No.	Author		
1	Los Angeles Irrigated Lands Group (LAILG)		
2	Ventura County Irrigated Lands Group (VCAILG)		
2.a	VCAILG – Comment Letter		
2.b	VCAILG – Exhibit 1 – Technical Comments

No.	Author	Comment	Response
1.1	LAILG	With the adoption of a WDR that is not guaranteed to be reviewed on a five-year timetable, it is incredibly important for the stability of the group that the new requirements are clear, reasonable, achievable, cost effective, sensible, and of vital importance, be actively enforced by the Los Angeles Region Water Quality Control Board (LARWQCB).	Comment noted.

Comment Due Date: August 18, 2023

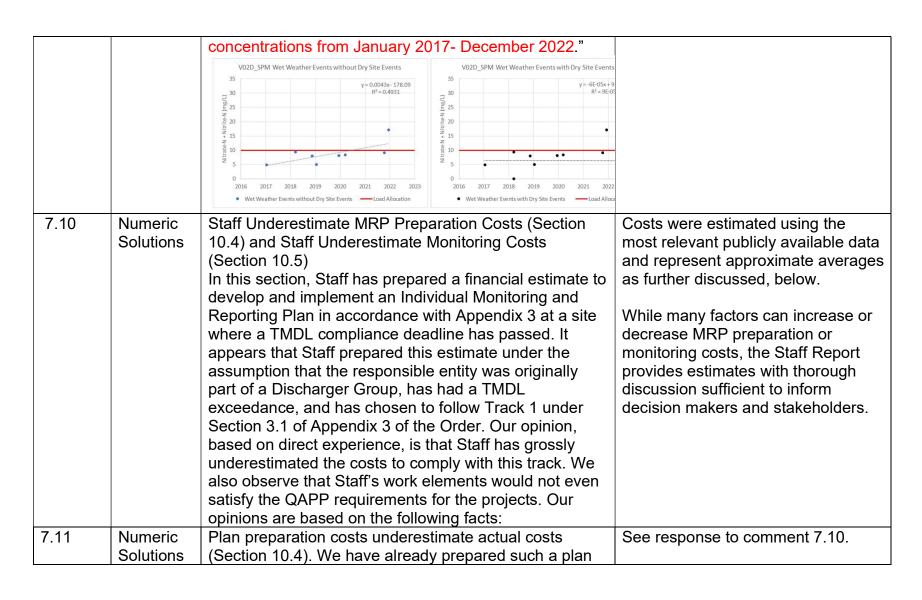
submitted and is not currently in the Los Angeles Water Board's possession.
7.9	Numeric Solutions	The V02D_SPM data in Figure 9 of the Staff Report should look like the data presented in the above figure on the right with wet weather events including instances of dry site conditions because it fairly considers all data in accordance with project QAPP and reasonably represents conditions at the subject site. Furthermore, the text above Figure 9 in the Staff Report (page 18) should be amended as follows (red text indicates additions): "In wet weather (Figure 9), all samples collected at both VRT_SANTO and VRT_THACH were below the water quality benchmark with relatively stagnant trendlines. Samples All representative samples collected at V02D_SPM, show an increasing trend in nitrate concentrations. with the exception of one sample, were below the water quality benchmark. The trendline describing all representative samples from this site suggests that there was no noticeable increase in nitrate	See comments 7.3 and 7.5 for discussion of Staff Report analyses. Figure 9 has been updated to reflect the revised data submitted by VCAILG on August 9, 2023, but no non-samples have been added to the figure.
